CHANDIGARH  
HOUSING  
BOARD

TYPICAL FLOOR PLAN  
ONE BED ROOM CATEGORY FLATS  
SECTOR 63  
CHANDIGARH (U.T.)

S.NO.	DESCRIPTION	SIGN.	DATE
REVISIONS			
CHIEF ARCHITECT			
 ARCHITECT 11/09/15		 ASSTT. ARCHITECT	
SCALE:		DATE: 10-9-2015	
DRAWN BY: 		204	36
PLANNING ASSTT.		JOB NO.	DRG. NO.
TYPICAL FLOOR PLAN			
TWO BED ROOM CATEGORY FLATS			
SECTOR 63			
CHANDIGARH (U.T.)

TYPICAL FLOOR PLAN  
 THREE BED ROOM CATEGORY FLATS  
 SECTOR 63  
 CHANDIGARH (U.T.)

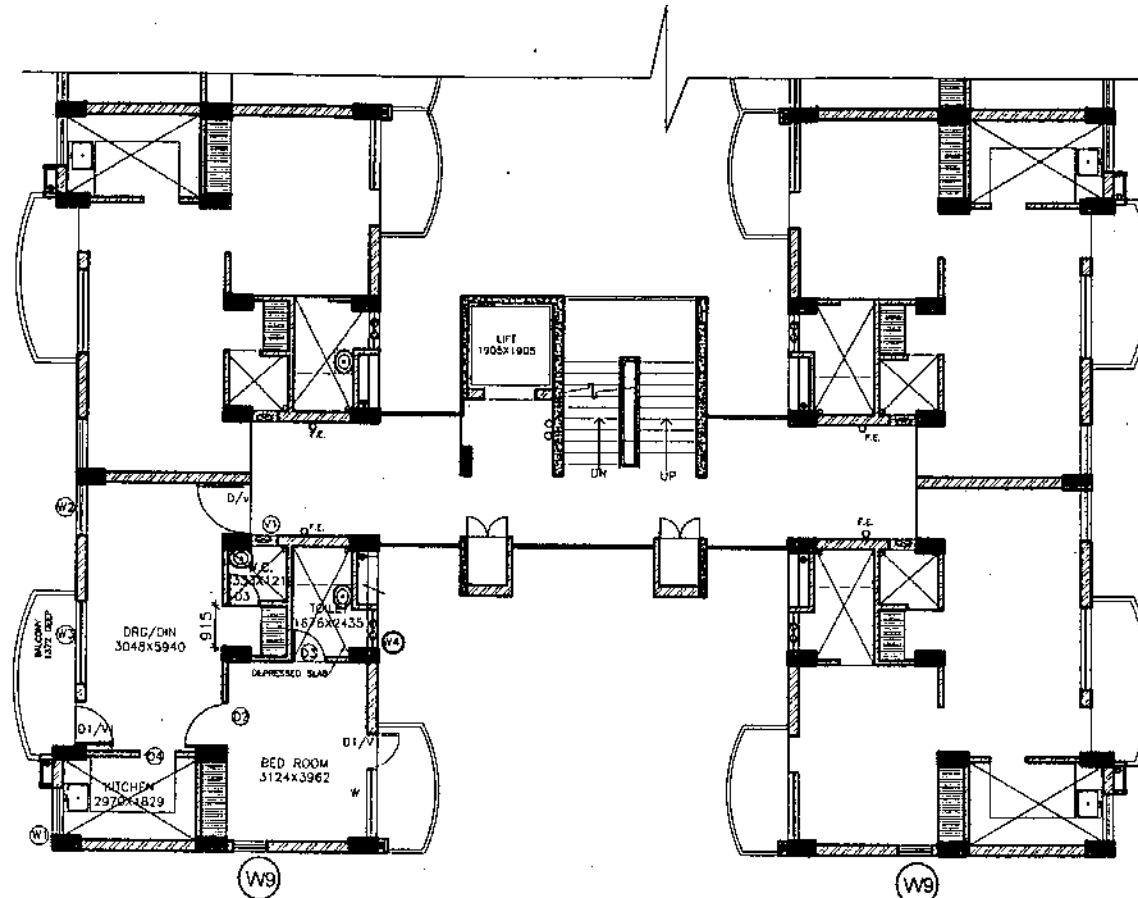
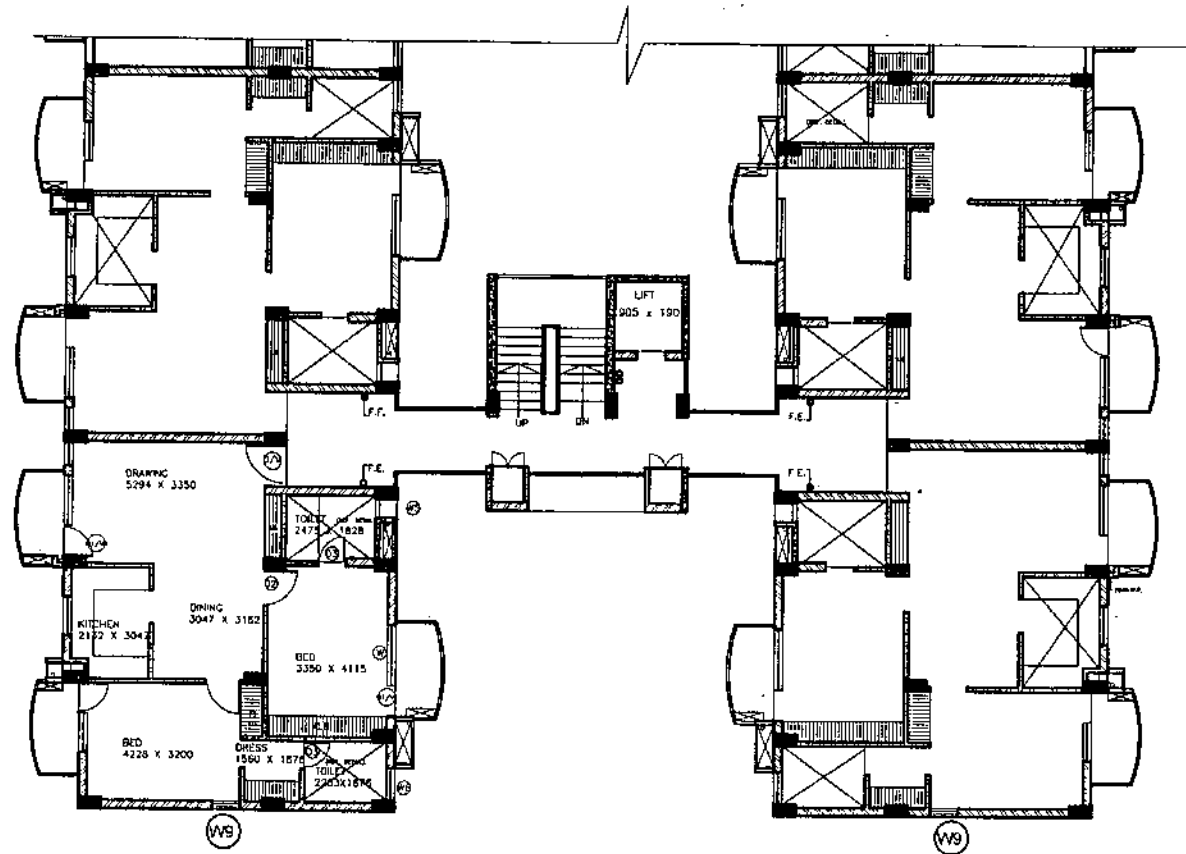
1. THE PROPOSAL OF ADDITIONAL WINDOW OF 760 MM. (2'-6") WIDTH HAVING CILL LVL. 685 MM. (2'-3"), IN END WALL WITH LINTEL LVL SAME AS OTHER WINDOWS OF D.U. ALLOWED UNDER CLAUSE A7 OF NEED BASED CHANGES 7-7-2015 IS MARKED ON THE DRGS. BASED ON APPROVED DRG. NO. 7, JOB NO. 206.
2. FOR ANY OTHER DETAIL / NOTES REF. DRG. NO. 7, JOB NO. 206.
3. IF REQUIRED BY THE ALLOTTEE TO ADD ANY ADDITIONAL WINDOW IN THE END WALL OF D.U. AS PER CLAUSE A7 THEN IT SHOULD BE ADDED AT THE LOCATION SHOWN AT W9
4. THE LOCATION, SIZE, CILL LVL. & LINTEL LVL. OF WINDOW SHOWN IN END WALL OF CORNER UNIT IS APPLICABLE OF ALL D.U. I.E. G.F. AND UPPER FLOORS SO THAT THE WINDOWS OF ALL FLOORS ARE VISIBLE IN SAME LINE IN ELEVATION.

TYPICAL FLOOR PLAN

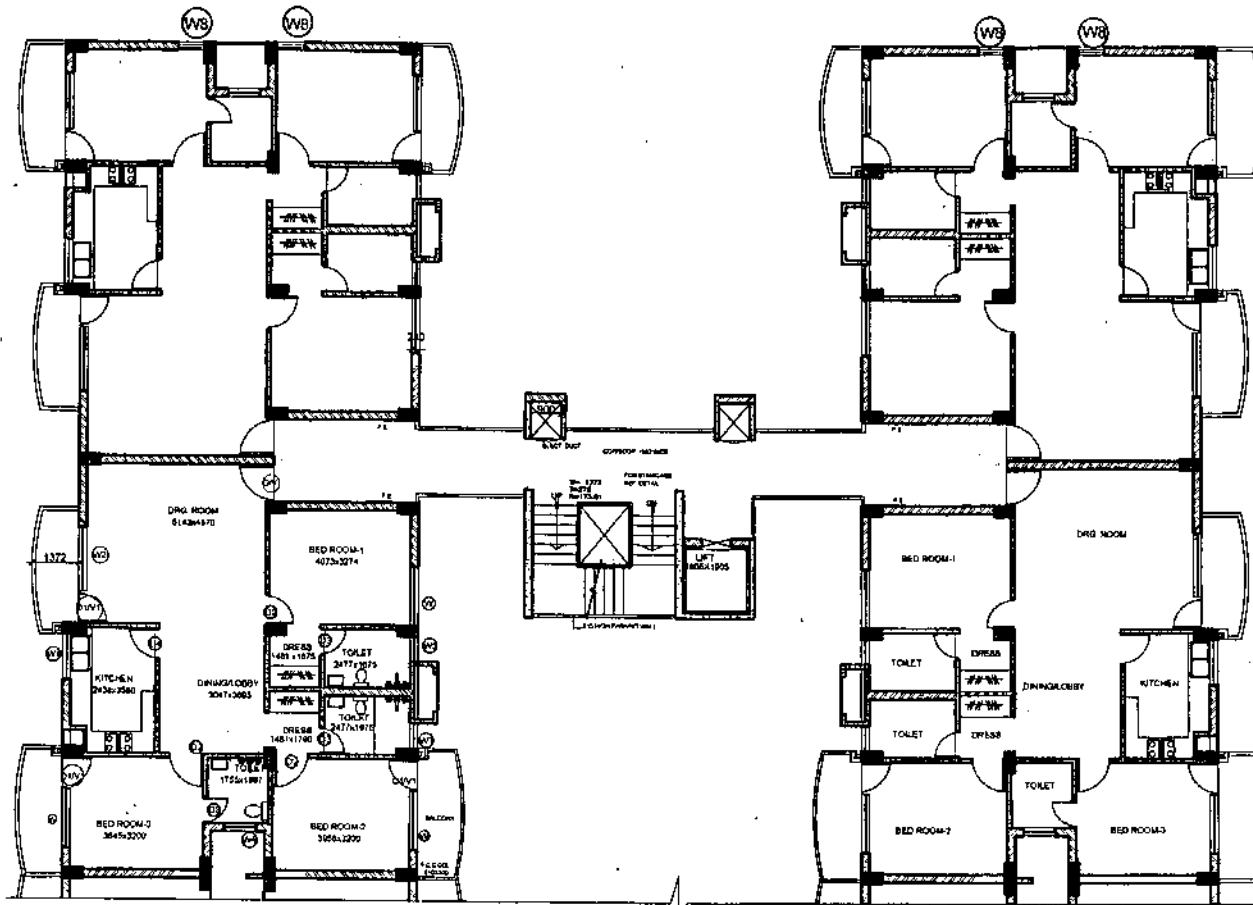
1. THE PROPOSAL OF ADDITIONAL WINDOW OF 760 MM (2'-6") WIDTH HAVING CILL LVL. 885 MM. (2'-3") IN END WALL WITH LINTEL LVL. SAME AS OTHER WINDOWS OF D.U. ALLOWED UNDER CLAUSE A7 OF NEED BASED CHANGES 7-7-2015 IS MARKED ON THE DRGS. BASED ON APPROVED DRG. NO. 15, JOB NO. 204.
2. FOR ANY OTHER DETAIL / NOTES REF. DRG. NO. 15, JOB NO. 204.
3. IF REQUIRED BY THE ALLOTTEE TO ADD ANY ADDITIONAL WINDOW IN THE END WALL OF D.U. AS PER CLAUSE A7 THEN IT SHOULD BE ADDED AT THE LOCATION SHOWN AT W9.
4. THE LOCATION, SIZE, CILL LVL. & LINTEL LVL. OF WINDOW SHOWN IN END WALL OF CORNER UNIT IS APPLICABLE OF ALL D.U. I.E. G.F. AND UPPER FLOORS SO THAT THE WINDOWS OF ALL FLOORS ARE VISIBLE IN SAME LINE IN ELEVATION.
